**PLANNED UNIT DEVELOPMENT  
& SUBDIVISION STAFF REPORT****Date: October 3, 2013**

<b><u>NAME</u></b>	Tuthill Square Subdivision, Hunter Addition to
<b><u>SUBDIVISION NAME</u></b>	Tuthill Square Subdivision, Hunter Addition to
<b><u>LOCATION</u></b>	4058 Old Shell Road (North side of Old Shell Road, 135'± West of Tuthill Lane, extending North to Stein Street)
<b><u>CITY COUNCIL DISTRICT</u></b>	District 7
<b><u>PRESENT ZONING</u></b>	R-1, Single-Family Residential District
<b><u>AREA OF PROPERTY</u></b>	3.6± Acres
<b><u>TIME SCHEDULE</u></b>	Immediately

## DETAIL SITE PLAN

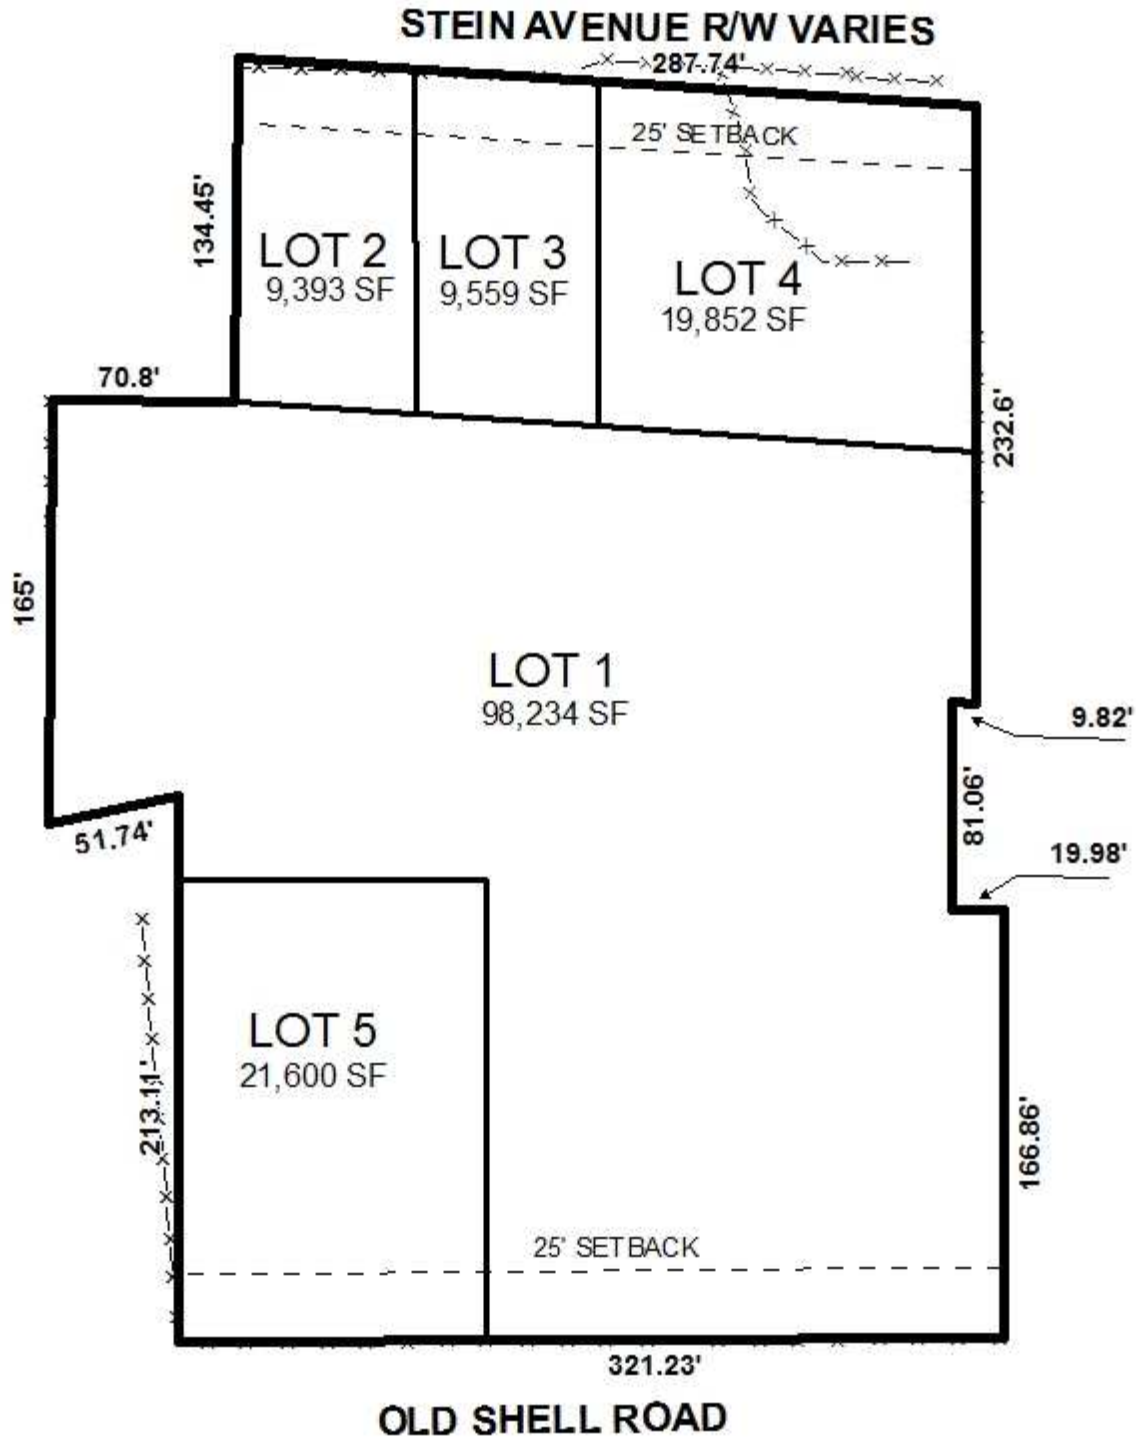
The preliminary plat illustrates the 25' minimum building setback along all street frontages, however one of the existing residences on the proposed Lot 4 is almost entirely within this setback, and comes as close as 7.5'± to the front property line. It appears that there are several structures in the area that may be within the 25' minimum setback line, however; none to this great of an extent. Planned Unit Developments have some flexibility in allowing reduced setbacks for a site, and upon review of City of Mobile aerial photography, it appears the encroaching structure has been in its current location since at least 1984. If approved, a note should be placed on the Final Plat that no future structures or building expansion will be allowed in the 25' minimum building setback.

The site fronts onto both Old Shell Road and Stein Avenue. Old Shell Road is a minor street, and should therefore have a right-of-way of 50'. The preliminary plat illustrates a varying right-of-way, therefore dedication should be made to provide 25' from the centerline if necessary. Stein Avenue is a minor street with ribbon curb and gutter, and is illustrated as having a compliant 50' right-of-way, making no dedications necessary.

It should be noted that most of the proposed lots, with the exception of Lot 5, have shared access with other lots, with Lots 2 and 5 not having any existing curb cuts. As a means of access management, Lots 1, 3, and 4 should be limited to existing curb cuts, and Lot 2 should be limited to one curb cut to Stein Avenue and Lot 5 should be limited to one curb cut to Old Shell Road, with the size, design, and location to be approved by Traffic Engineering and to comply with AASHTO standards.

Urban Forestry has requested that preservation status is to be given to the Three 84" Live Oak Trees and One 60" Live Oak Tree located on proposed Lot 1. Any work on or under these trees is to be permitted and coordinated with Urban Forestry; removal to be permitted only in the case of disease or impending danger. If approved, a note should be placed on the Final Plat indicating this.

- 1) retention of the lot sizes in square feet and acres;
- 2) dedication to provide 25' from the centerline along Old Shell Road;
- 3) retention of the 25' minimum building setback line along all street frontages;

- 4) placement of a note stating that no additional structures will be allowed to be constructed within the 25' minimum building setback line;
- 5) placement of a note stating that Lots 1, 3, and 4 are limited to existing curb cuts; Lot 2 is limited to one curb cut to Stein Avenue; and Lot 5 is limited to one curb cut to Old Shell Road;

- 7) placement of a note stating preservation status is to be given to the Three 84" Live Oak Trees and One 60" Live Oak Tree located on proposed Lot 1. Any work on or under these trees is to be permitted and coordinated with Urban Forestry; removal to be permitted only in the case of disease or impending danger;
